STAFF REPORT: JULY 12, 2023 MEETING

APPLICATION NUMBER: 23-8404

ADDRESS: 8022 KERCHEVAL

SCOPE: MASONRY REPLACEMENT, WINDOW REPLACEMENT

Staff photos, May 30, 2023

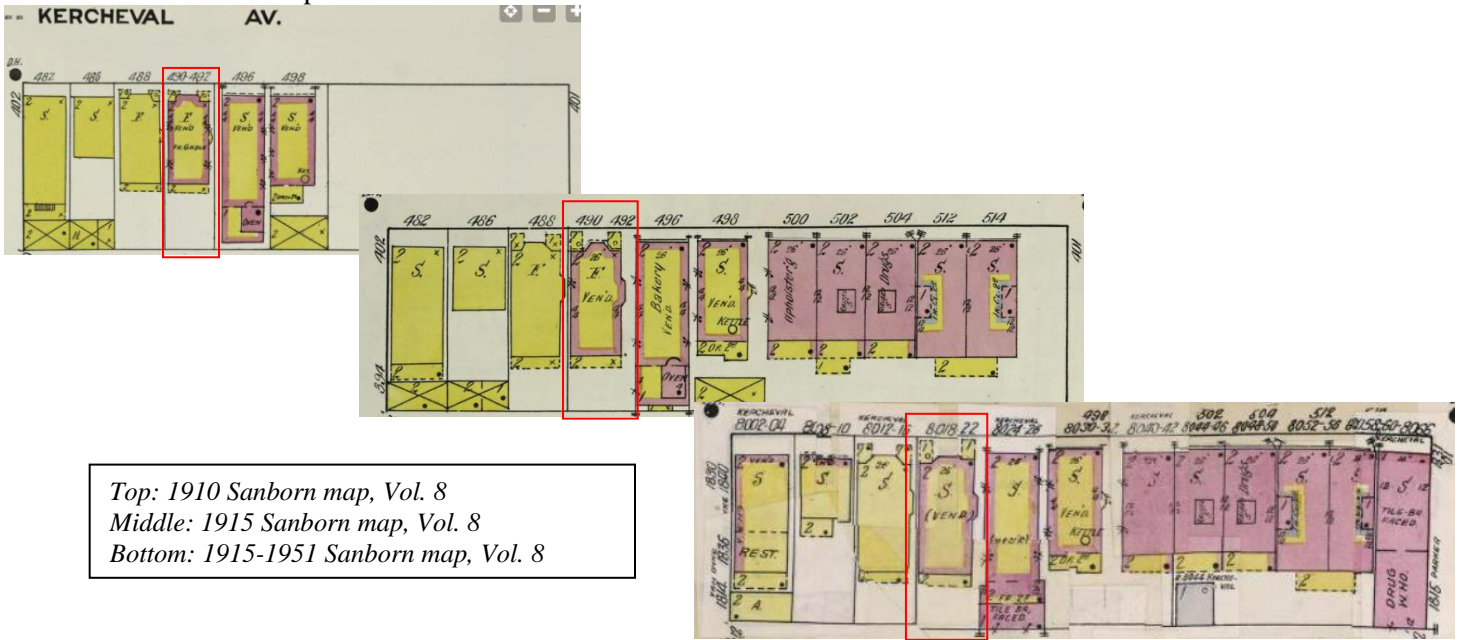
Upon close inspection of the site visit photographs, staff noticed that the vertical mortar joints are flush with the brick, while the horizontal mortar joint have a raked/recessed joint. This creates the effect of a traditional brick pattern when looking at a façade straight on and offering strong horizontal lines when looking at a wall from an angle.

8022 Kercheval District designation photos, 1983. Historic Designation Advisory Board 8016 Kercheval

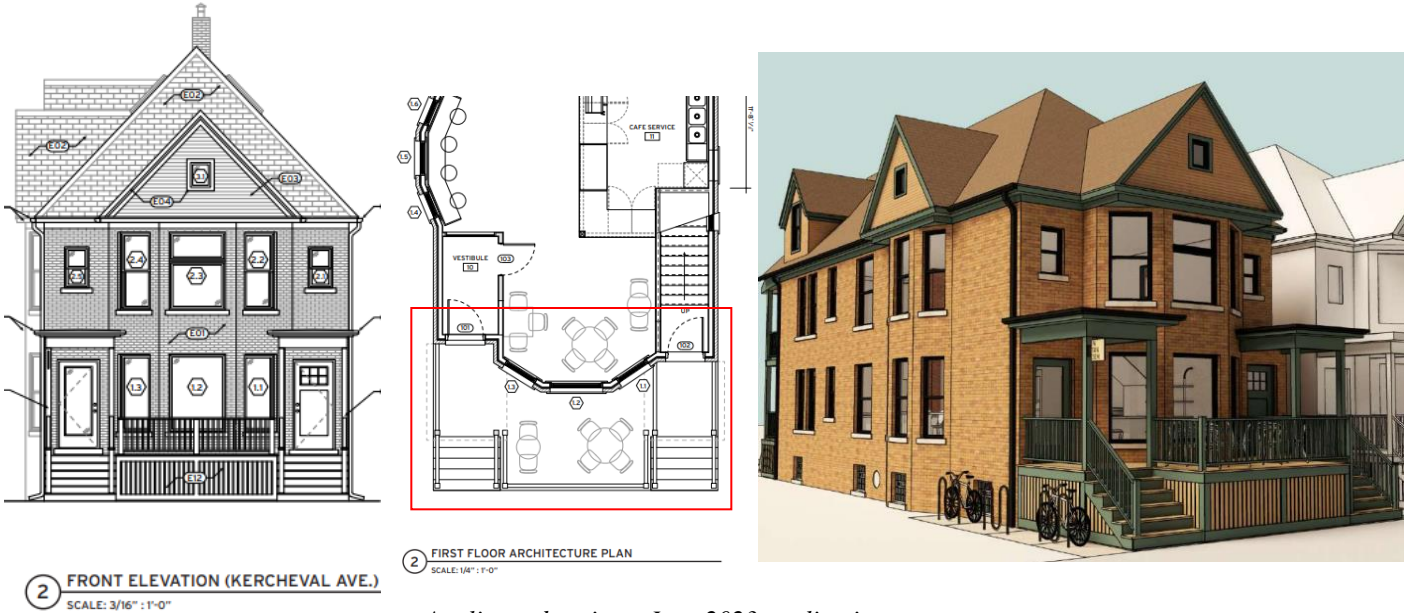
- Not only were 8022 and 8016 Kercheval erected as the only two residential structures on this block, the footprint and design of the two buildings are almost identical - the difference being the exterior wall surfaces (brick vs. wood lap siding).

Google street view: above - August 2015; right – August – 2021. The removal of the dark red paint at the front elevation, and reintroduction of contrasting mortar joints, created a more visible change at the side walls faced with common brick.

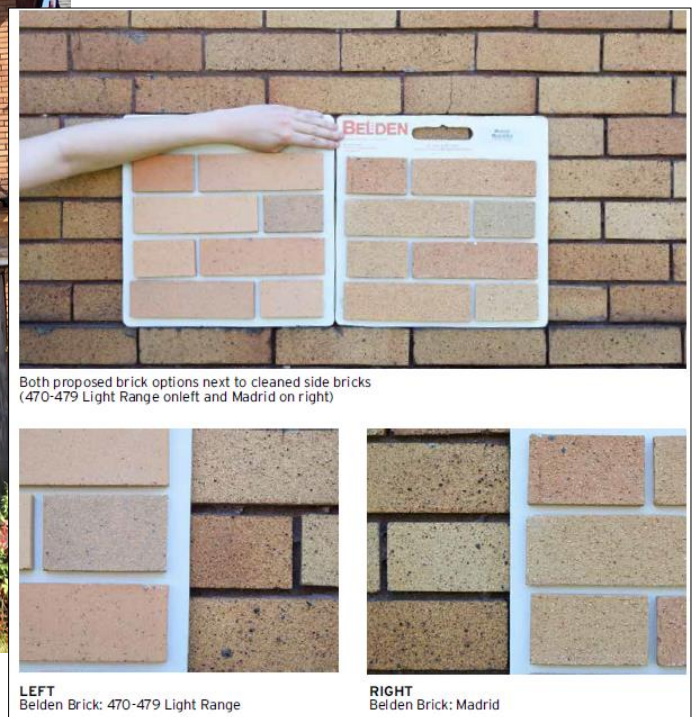
- The structure was erected as a commercial, masonry building. The street-facing elevation has face brick, with common brick used at the side and rear elevations. The historic detail of wrapping the face brick around the front corners of the buildings is a distinctive character-defining feature of this property.
- Creating a similar detail at 8016 Kercheval, which had face brick applied to all four elevations of the structure, would not meet the Secretary of the Interior Standards for Rehabilitation.

Applicant window schedule and photos of window opening 1.3.

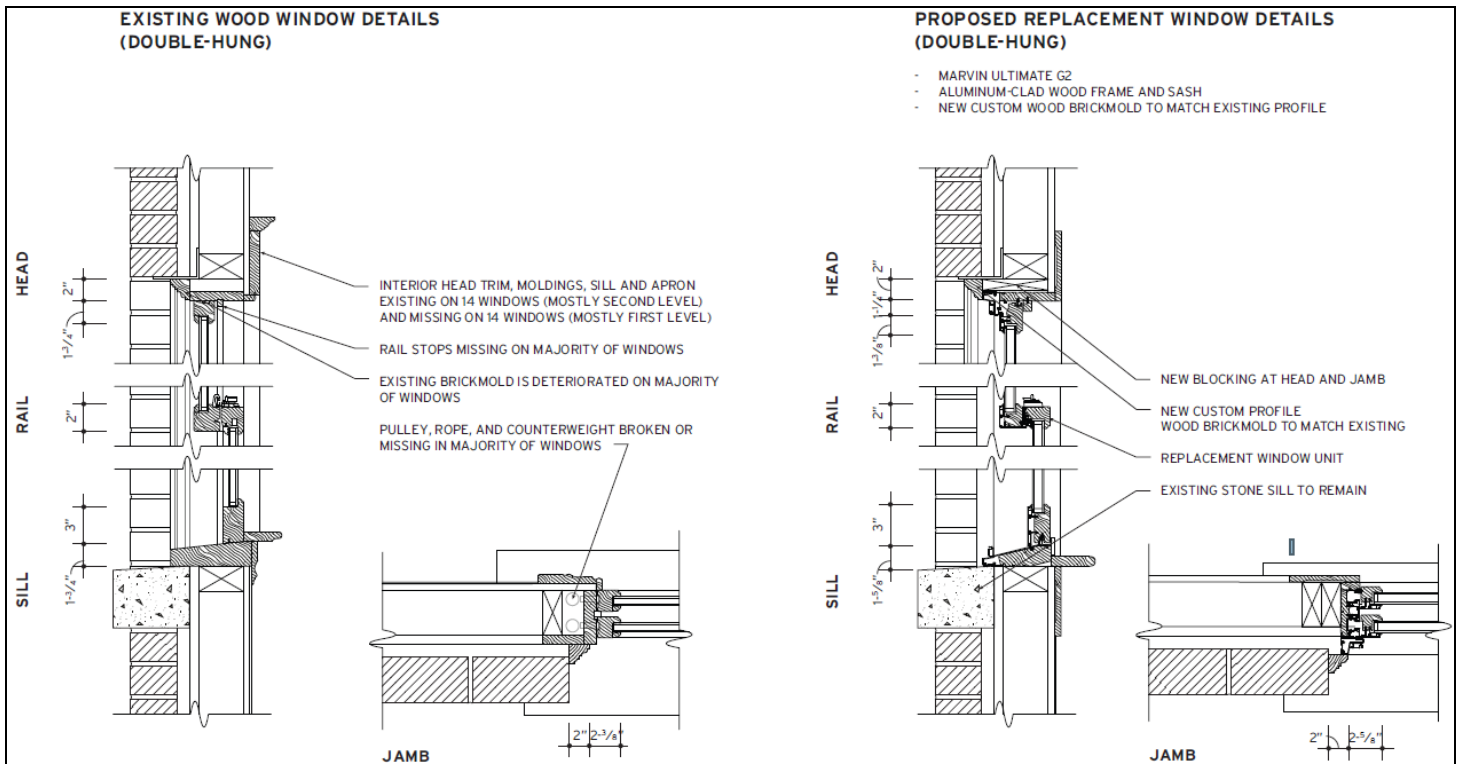
- The submitted window schedule states that repair to differing levels is needed, but the applicant hasn’t provided written repair estimates and/or written testimonials from window repair companies stating that the windows are beyond repair. Therefore, staff determines that the replacement proposal doesn’t meet Secretary of the Interior Standard 6. The Commission, however, may take additional circumstances under consideration when making its decision.

Recommendation One – Denial – Window replacement

- The windows on the dwelling are distinctive character-defining features.
- Written estimate or testimonials from window repair companies confirming the existing windows are deteriorated beyond repair were not submitted.
- It is not clear if the proposed replacement window is an adequate match to the historic sash, particularly in its placement within the window opening.
